Subject: Blackbuck Resources, LLC; Ballard SWD #1 (SWD-2688; pSYS2605432926)  
C-108 Supplemental Submittal

The purpose of this letter is to submit supplemental information associated with Blackbuck Resources, LLC's (Blackbuck) C-108 application for the proposed Ballard SWD #1 (SWD-2688; pSYS2605432926). This information is being provided to address OCD's comments in a recent Administrative Completeness Checklist. A list of the updates to the application is included below.

# **Proposed SWD Data and Wellbore Diagram**

# Ballard SWD #1

## Proposed Wellbore Diagram

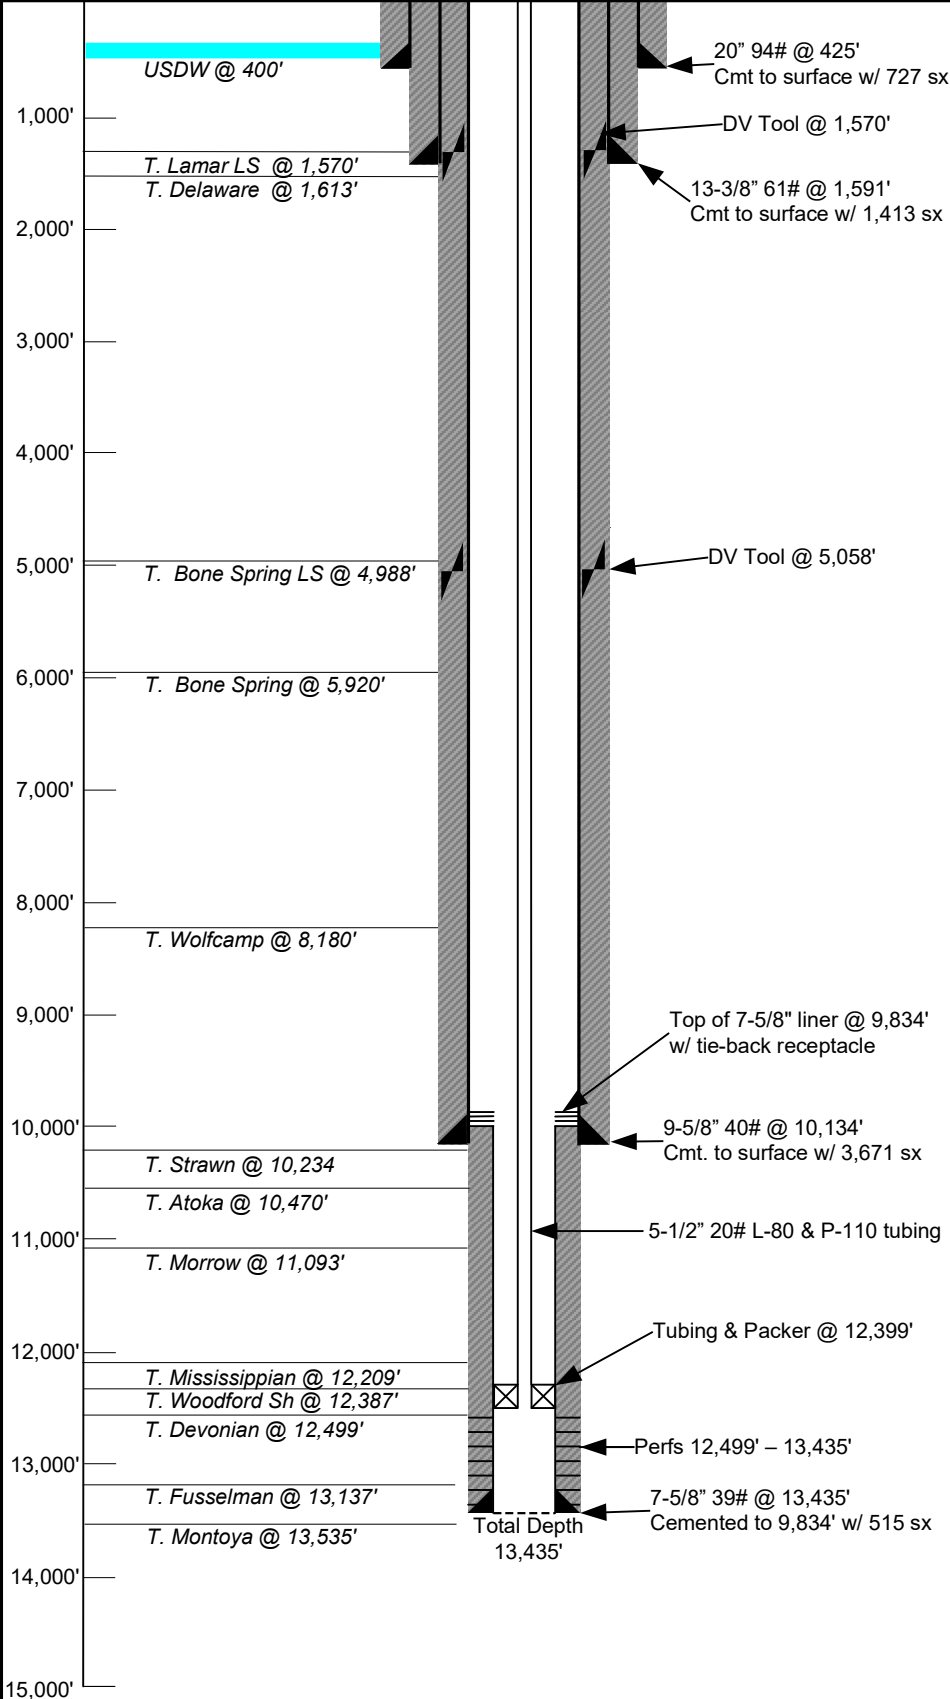
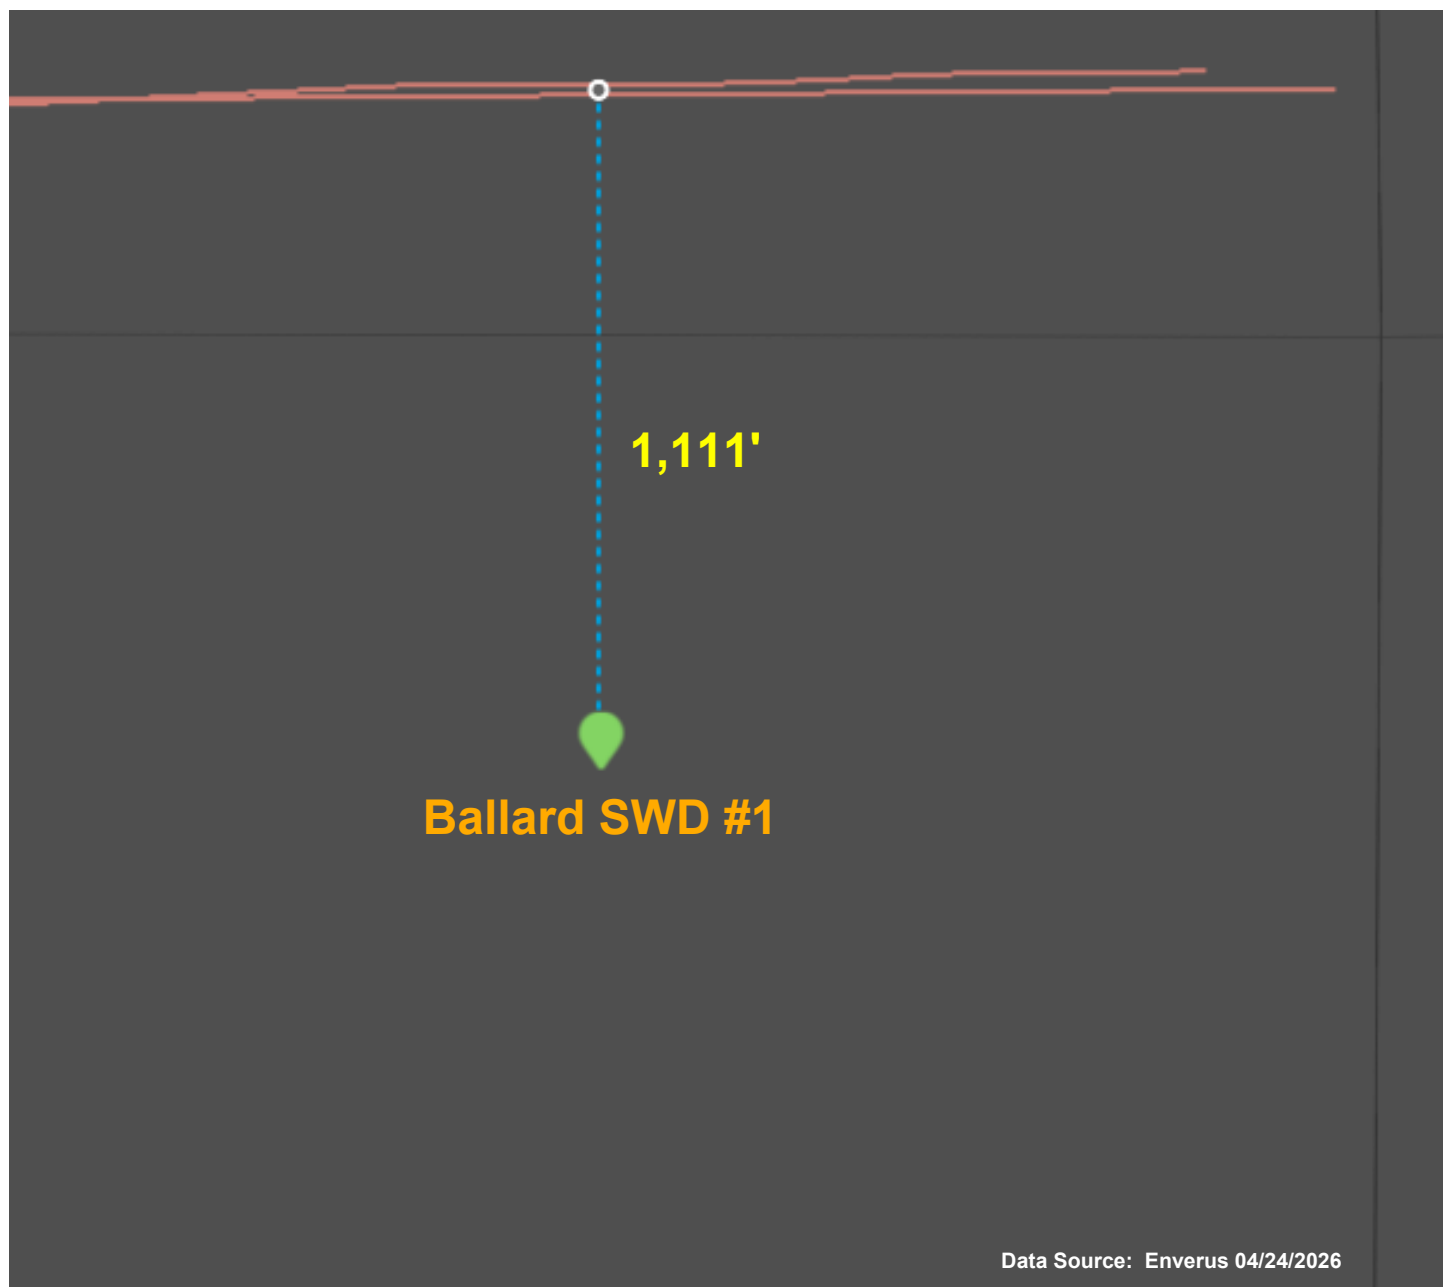
- **Revise from Open-Hole to Cased-Hole:** Revised completion from Open-Hole to Cased-Hole and updated the liner depth and cement volumes in the Tabulated Casing Data and Wellbore Diagram (WBD) accordingly.

- see **Attachment A** for Updated Tabulated Casing Data (p. 3) and Updated WBD (p. 5)
- **No Underlying USDW Statement:** Added a Statement to the Geology Data clarifying that "No USDWs were identified underlying the proposed injection interval."

**Casing Size:** 7-5/8 in  
**Casing Type:** 39 lb/ft HCL FJ  
**Casing Depth:** 9,834 - 13,435 ft  
**Hole Size:** 8-3/4 in  
**Top of Cement:** Surface  
**Sks Cement:** 515 sx  
**Cement Type:** Class H + additives

**Formation(s):** Devonian-Silurian  
**Top:** 12,499 ft  
**Bottom:** 13,435 ft  
**Hole size:** 7-5/8 in  
**Cased or Open-Hole:** Cased-Hole
